TEMPORARY PROCEDURE CHANGE FORM		T.P.C. No.: 84-32-TISI	
		DATE: 6-5-84	
Procedure No.	Revision No.	Check One:	
PT-10Y-K.5	"0"	Operations Procedure	Test Procedure ✓
Procedure Title: INSERVICE PRESSURE TEST, CONTAINMENT SPRAY PUMP 21 DISCHARGE HEADER PIPING			
Description of Change: CHANGED TEST PRESSURES PER ATTACHED PAGES.			
Reason For Change: 1.) TO CORRECT TEST PRESSURE BASED ON DESIGN SPECIFICATION OF LINE PRESSURE. (THIS LINE IS CLASS 301 INSTEAD OF CLASS 601) 2.) TO DEFINE OPERABILITY AND ACCEPTANCE CRITERIA AS REQUIRED BY ASME SECTION XI			
Temporary procedure changes which involve a change of intent require a pre-implementation SNSC review, <u>except</u> when continued or safe plant operation is in jeopardy. For these exceptions, C.O.E. concurrence is required.			
Change Of Intent	YES	NO X	C.O.E. Concurrence:
Initiator:	Title:	S.W.S. Approval:	Date:
DON SHERMAN	TEST ENG.	[Signature]	6/6/84

INDIAN POINT STATION

UNIT NO. 2

INSERVICE PRESSURE TEST, CONTAINMENT SPRAY PUMP 21 DISCHARGE HEADER PIPING

INSERVICE
 PRESSURE
 TEST
 PROCEDURE No. PT-10Y-K.5
 FIGURE No. 1

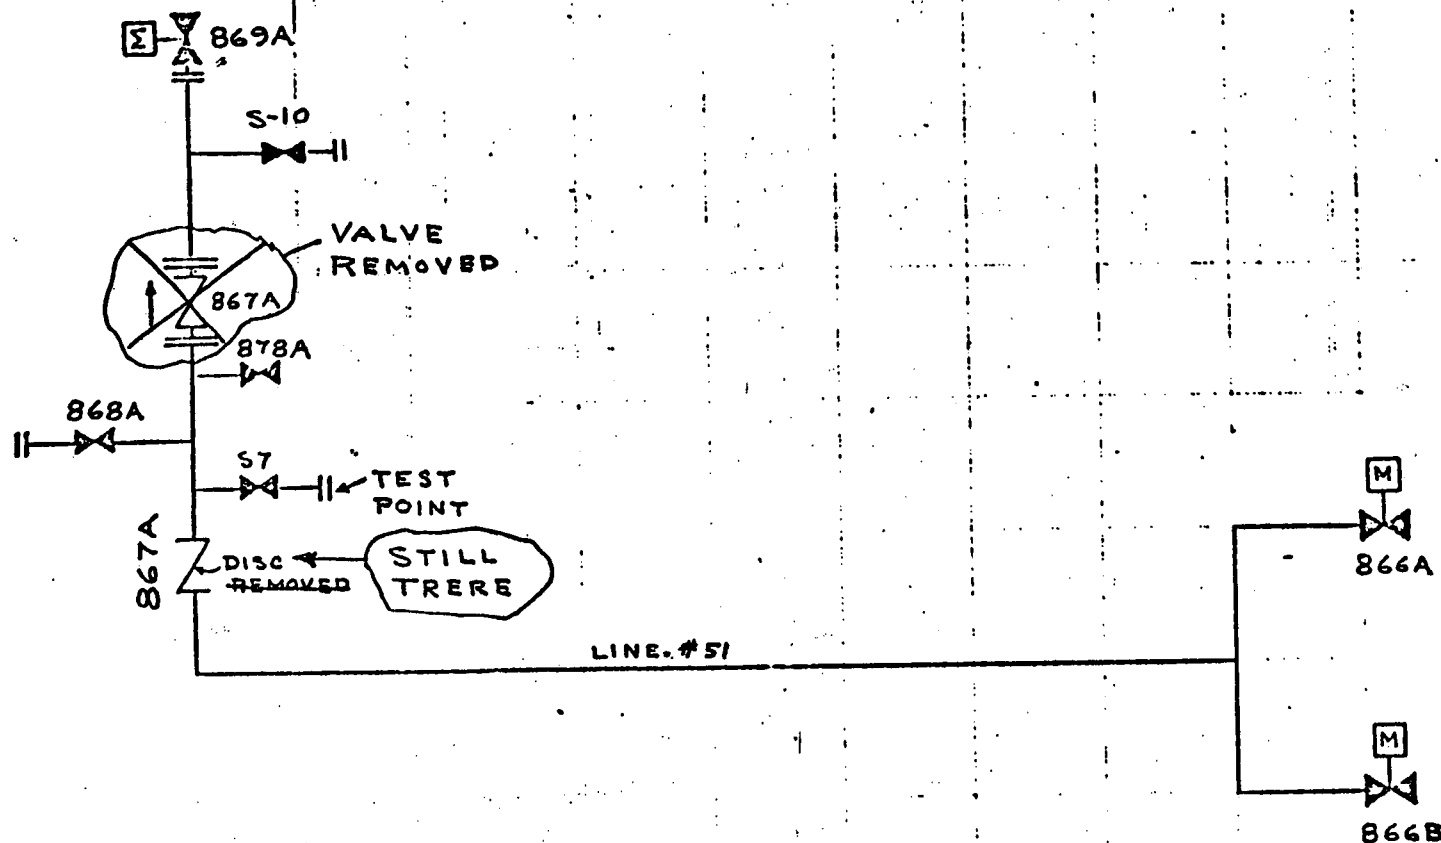
MIN. TEST PRESSURE 750 462 PSIG
 MAX. ALLOW PRESSURE 780 485 PSIG
 TEST RELIEF VALVE SET 725 PSIG
 TEST GAGE RANGE 0-1125-2250 PSIG
 693-1386

T.P.C. 84-32-TISI
 6-5-84 D.X.L.
